CPED STAFF REPORT

CPC Agenda Item #7
July 14, 2014
BZZ-6616

Property Location: 300 South 2nd Street
Project Name: Mill City Quarter Phase I
Prepared By: [Janelle Widmeier](#), Senior City Planner, (612) 673-3156
Applicant: Mill City Quarter LLC
Project Contact: Gretchen Camp, BKV Group Inc.
Request: To allow a new 6-story, mixed use building with ground floor retail and 150 dwelling units.

EXTERIOR
ELEVATIONS

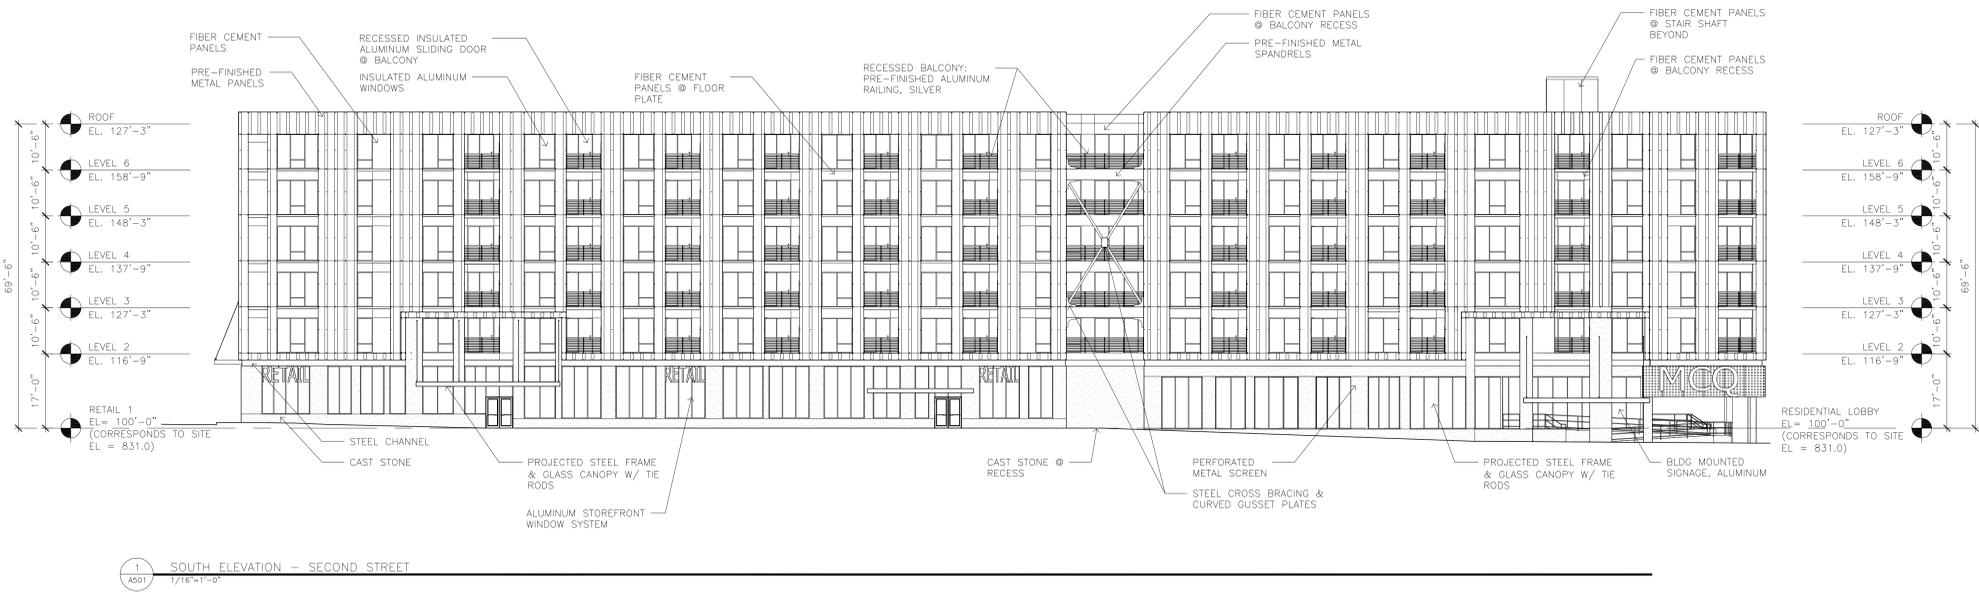
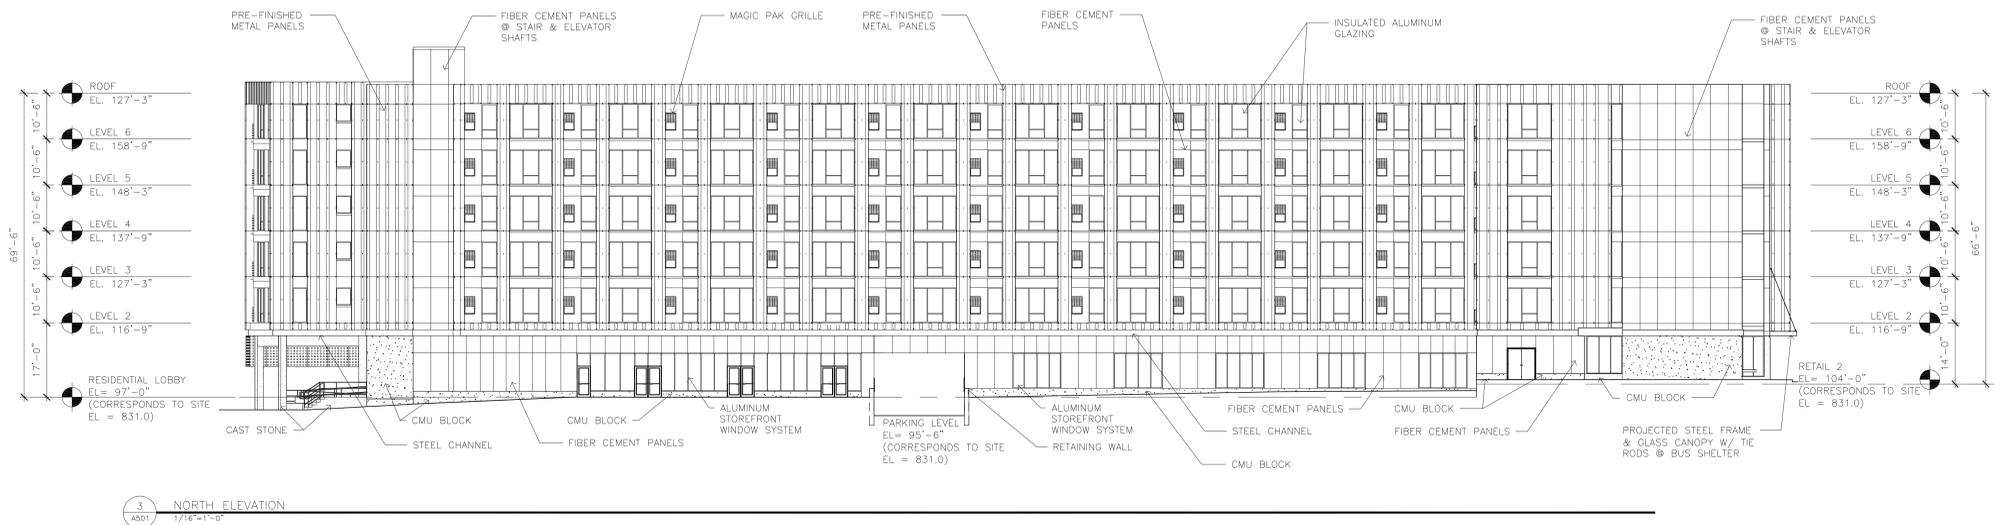
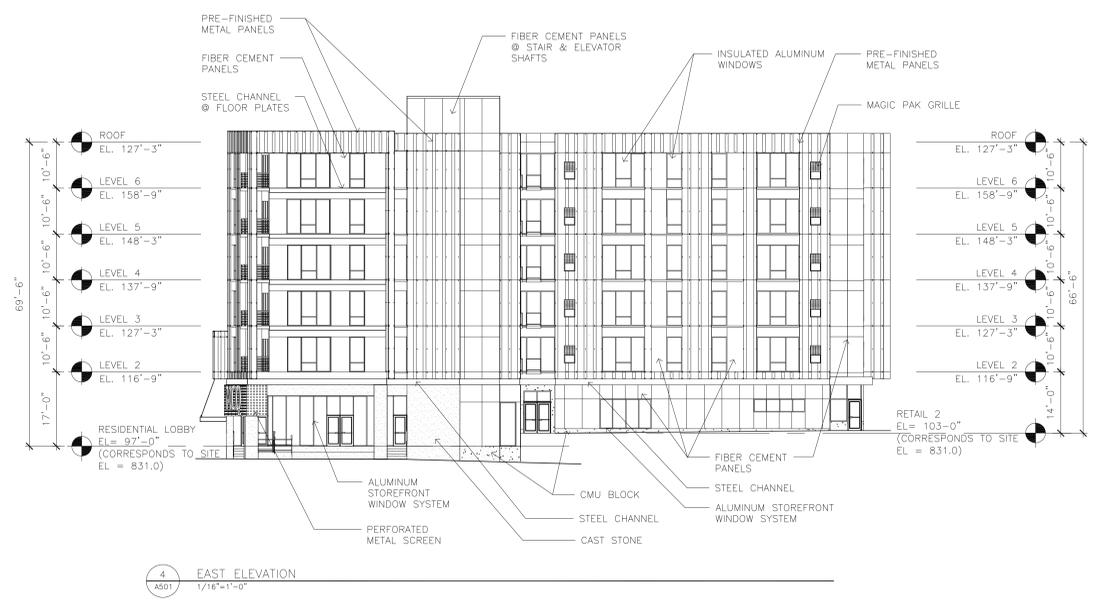
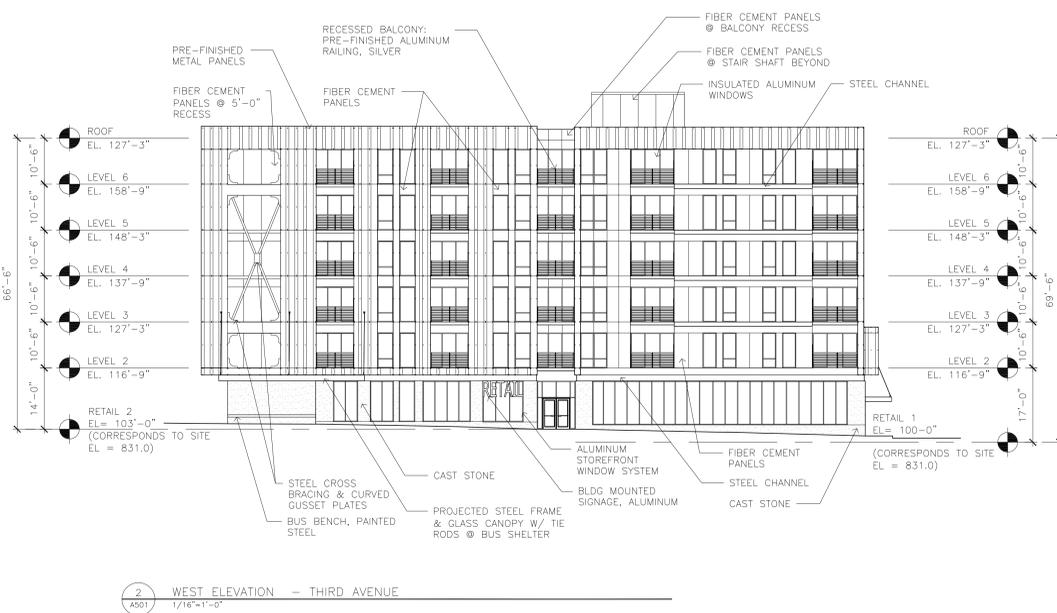
- Exterior materials would be durable and include cast stone, concrete masonry unit block (CMU), fiber cement, metal panel and glass. The amount of fiber cement would not exceed 30 percent on any elevation. The CMU is proposed in lieu of cast stone on interior facing walls where it is less visible from the public streets. On the plans that were reviewed by the HPC, cast stone was proposed on the north first floor wall between the housing entry and bus shelter. The plans currently show CMU in that location. Because this wall will be visible from 3rd Avenue, the cast stone will need to be provided as approved by the HPC.

- *Materials:* The majority of the non-fenestration materials of each façade is not brick, stone or cast stone. Proposed materials include cast stone, concrete masonry unit block (CMU), fiber cement, metal panel and glass. As currently shown on the plans, the proposed use of cast stone is limited to the first floor elevations on the east, west and south elevations. On the plans that were reviewed by the HPC, cast stone was proposed on the north first floor wall between the housing entry and bus shelter. The plans currently show CMU in that location. Because this wall will be visible from 3rd Avenue, the cast stone will need to be provided as approved by the HPC. With this one exception, the proposed materials have been reviewed and approved by the HPC, who found that the proposed materials were appropriate for new construction at this location in the historic district. Recently constructed projects have been allowed to deviate from this requirement although the primary material has still been brick with the exception of the MacPhail Center for Music (outside of the historic district) and the Guthrie, both of which are nonresidential structures.

2. The applicant shall provide additional cast stone on the north elevation, consistent with the approvals granted by the Heritage Preservation Commission.
